RHODE ISLAND DEPARTMENT OF TRANSPORTATION

Bridge Group 54A -Kingston Rd Bridge

NOTICE TO PROSPECTIVE BIDDERS

ADDENDUM NO. 2 Prospective bidders and all concerned are hereby notified of the following changes in the Plans, Specifications, Proposal and Distribution of Quantities for this contract. These changes shall be incorporated in the Plans, Specifications, Proposal and Distribution of Quantities, and shall become an integral part of the Contract Documents.

**GRS WALL AT
NORTH ABUTMENT**

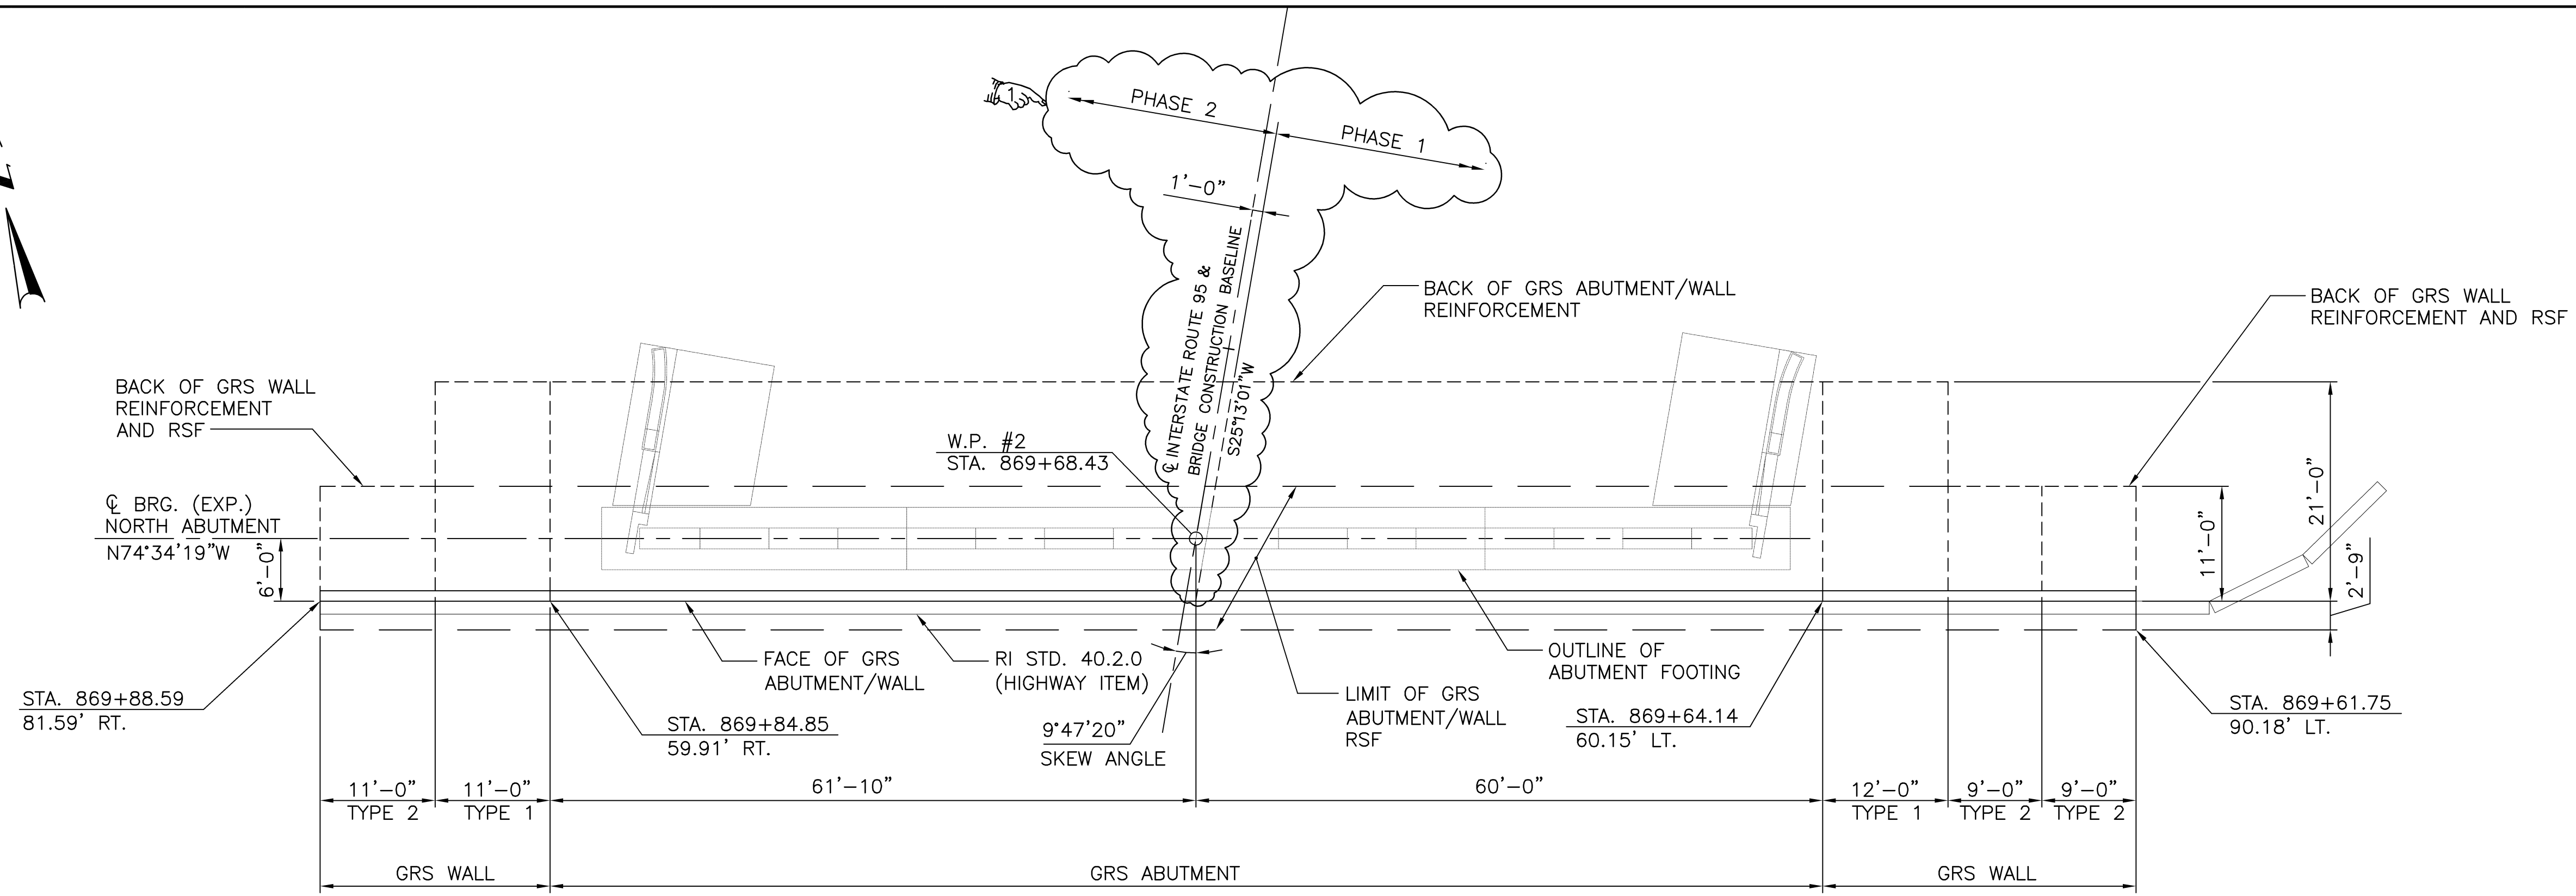
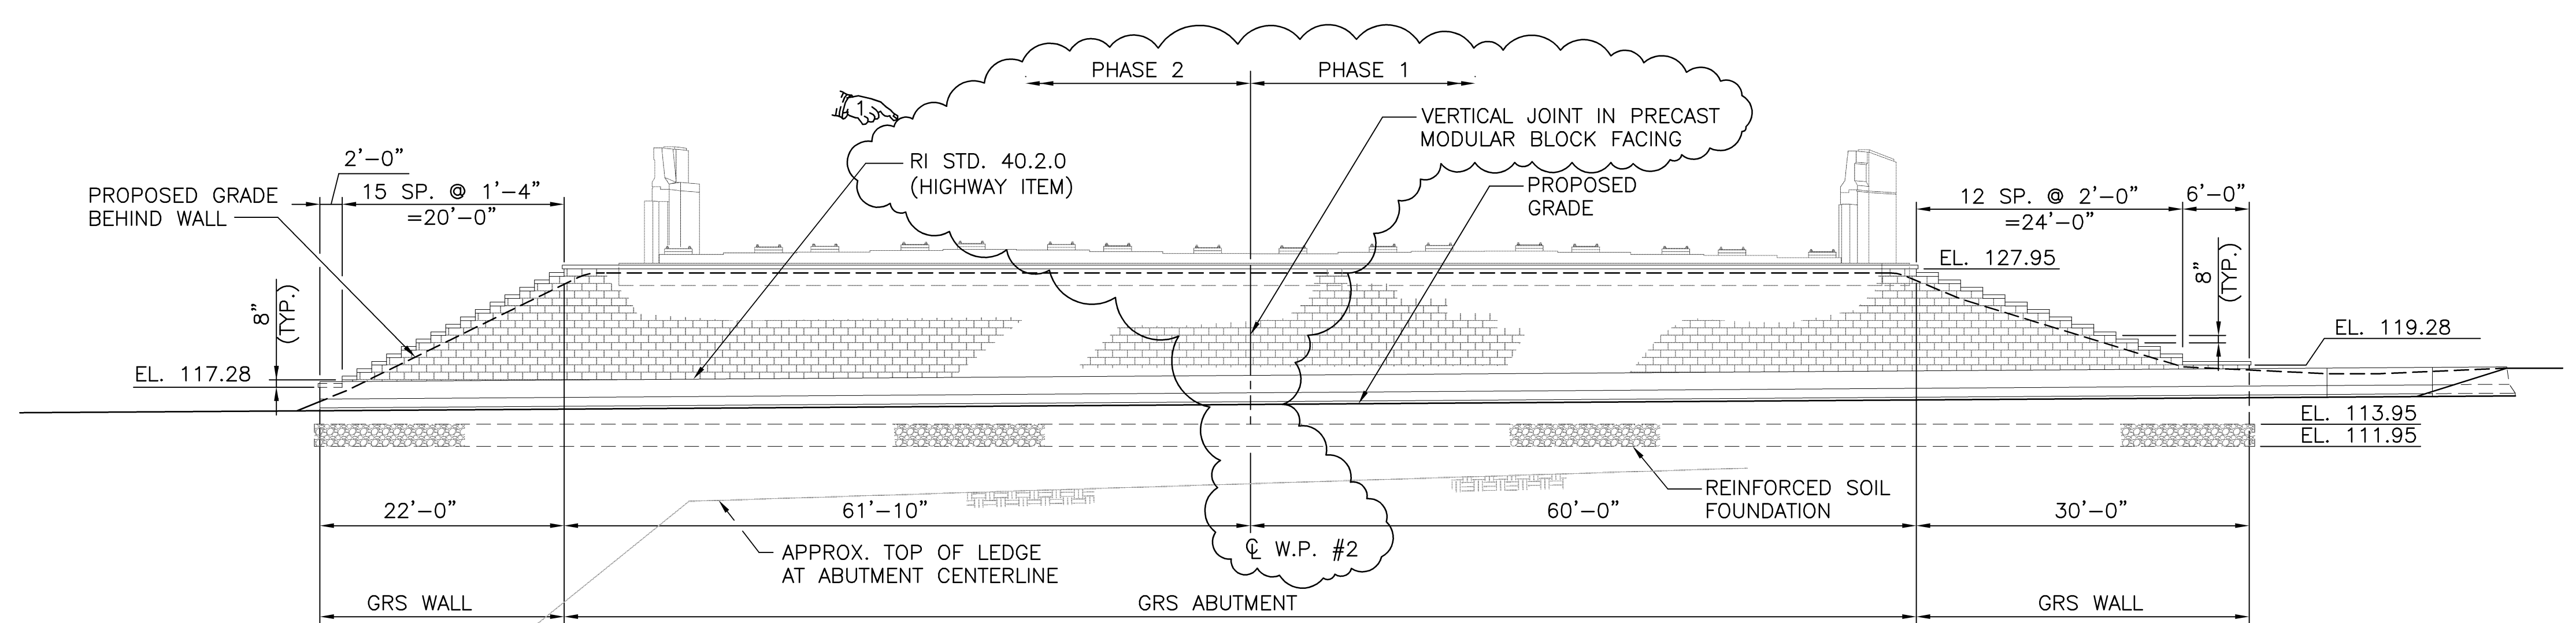
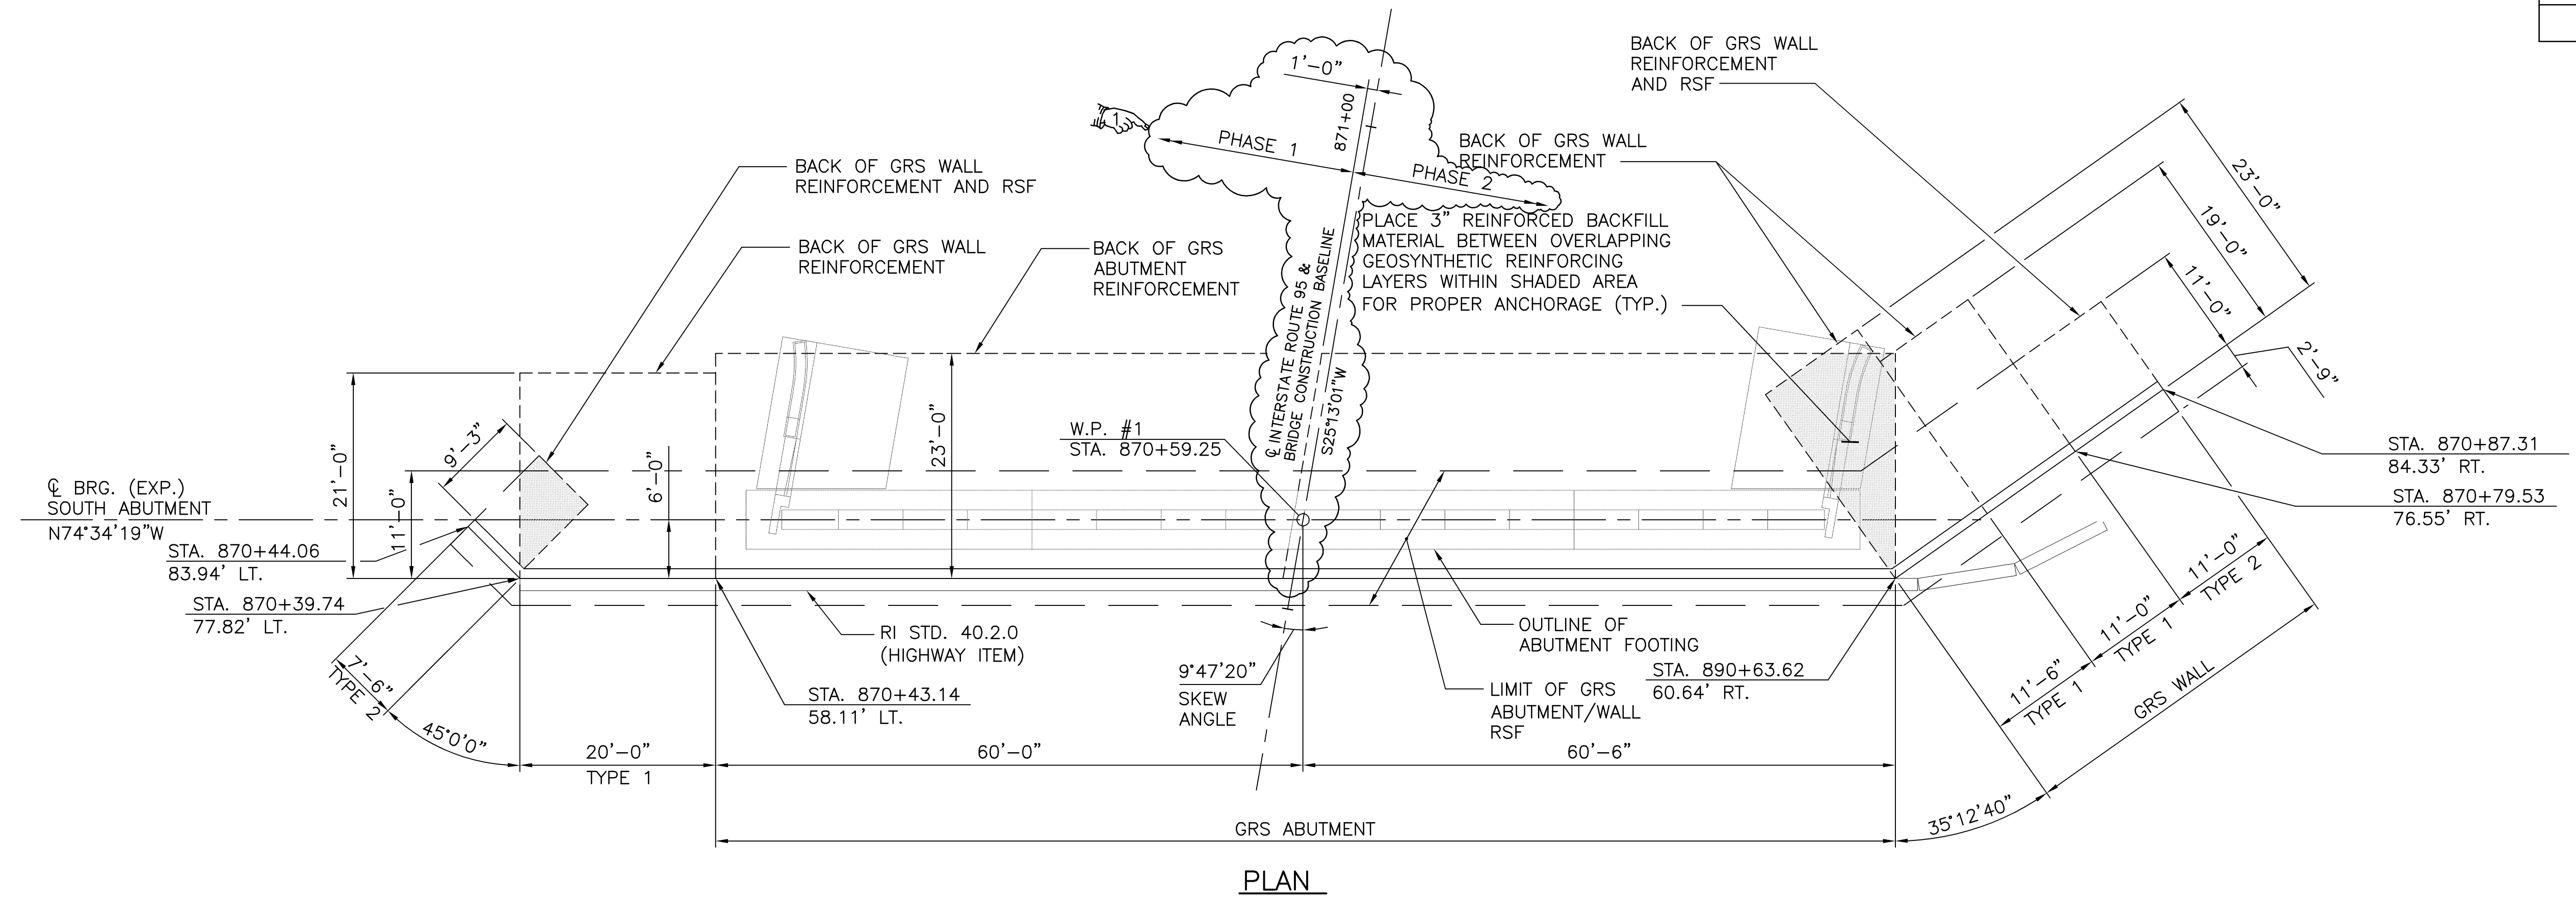
Remove Volume 2 Sheet No. 14 in its entirety and replace it with revised Sheet No. 14 (R-1) attached to this Addendum No. 2. GRS Wall at North Abutment sheet has been revised.

KINGSTON ROAD BRIDGE No. 403
GRS WALL AT
SOUTH ABUTMENT

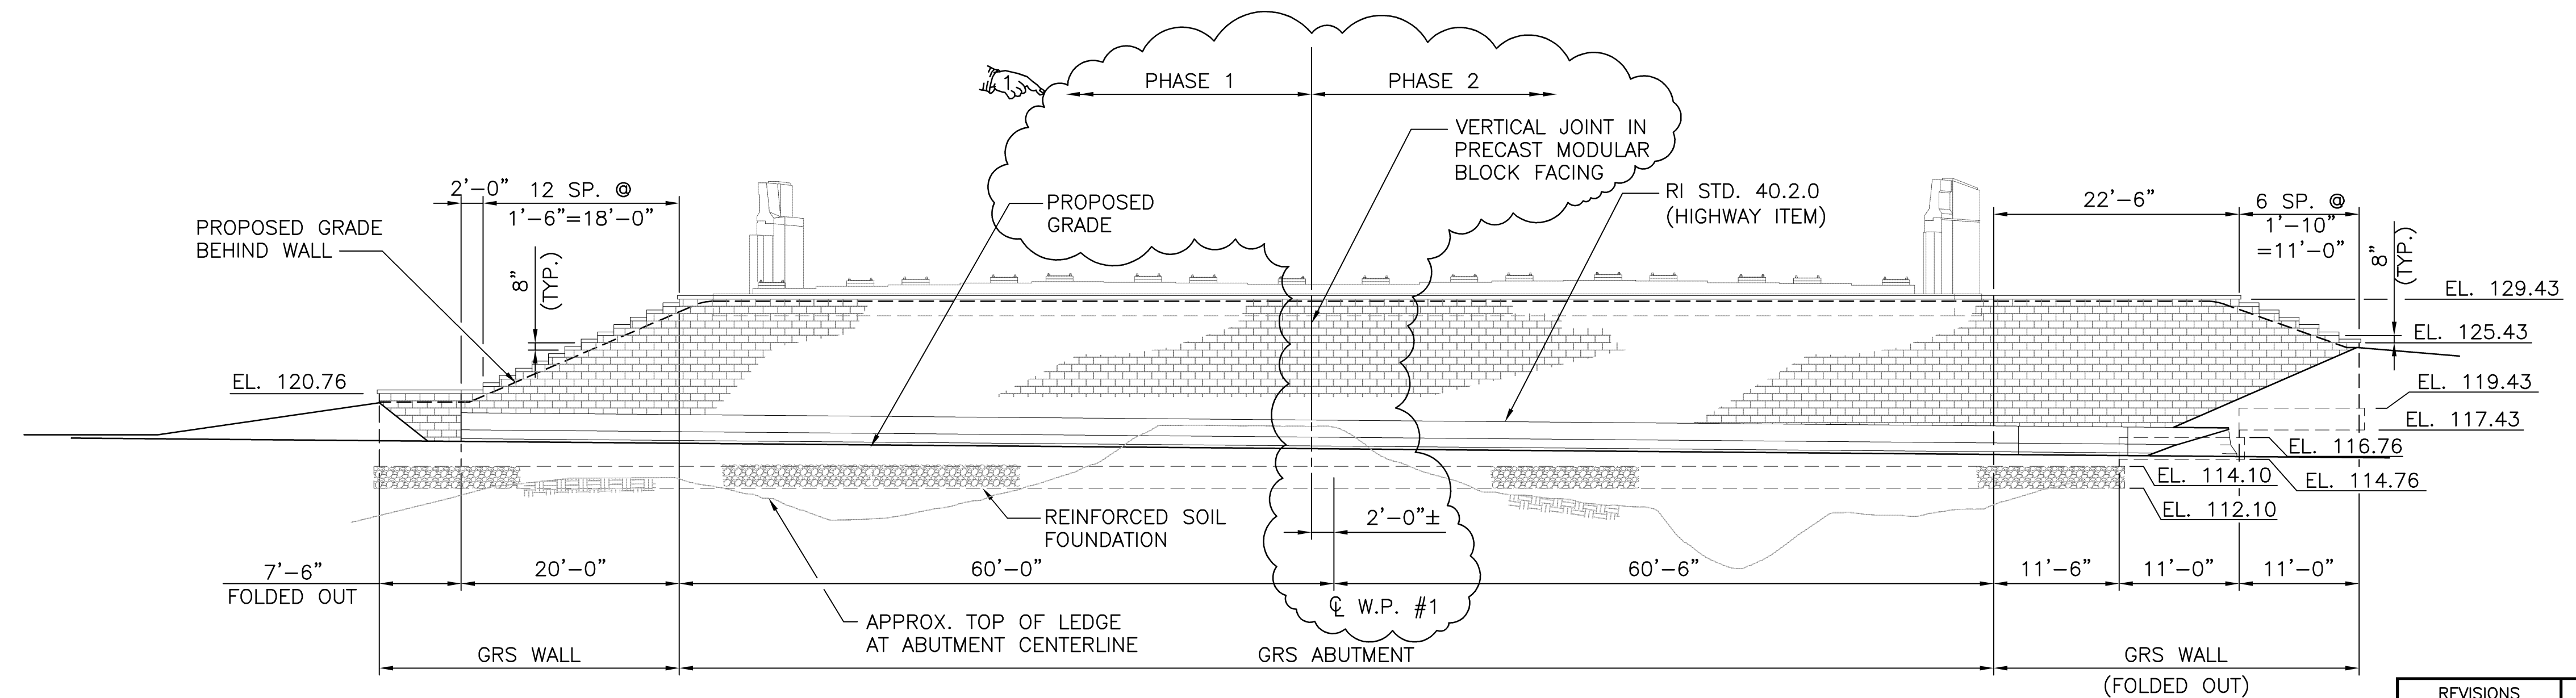
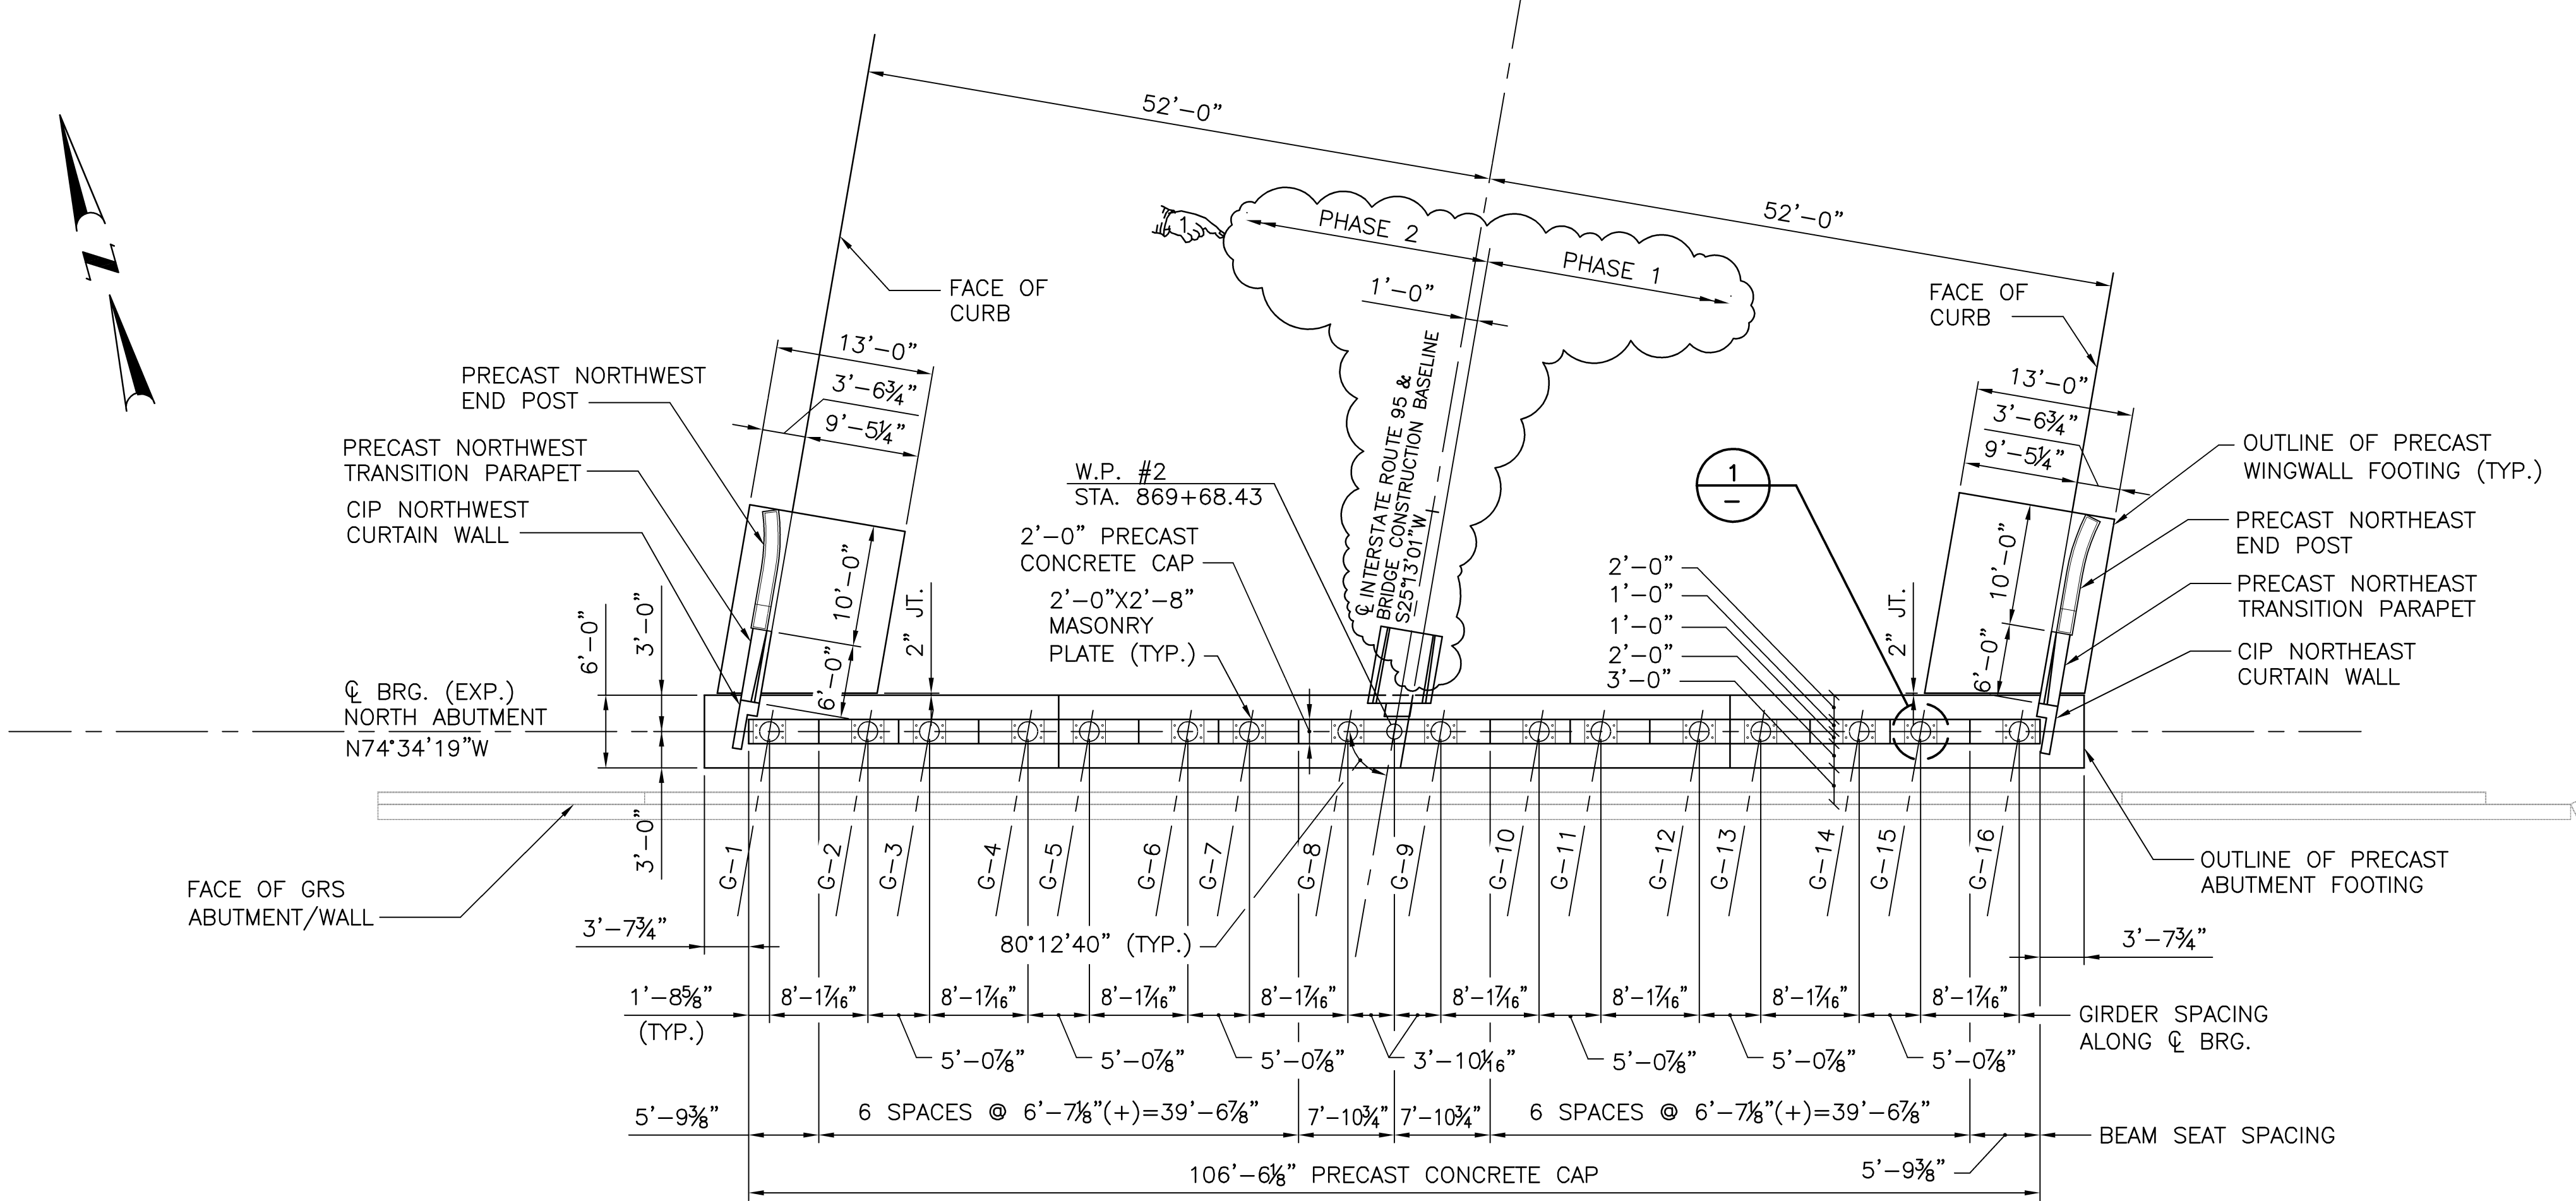
3. Volume 2 Plan Sheet No. 15 - GRS Wall at South Abutment
Remove Volume 2 Sheet No. 15 in its entirety and replace it with revised Sheet No. 15 (R-1) attached to this Addendum No. 2. GRS Wall at South Abutment sheet has been revised.
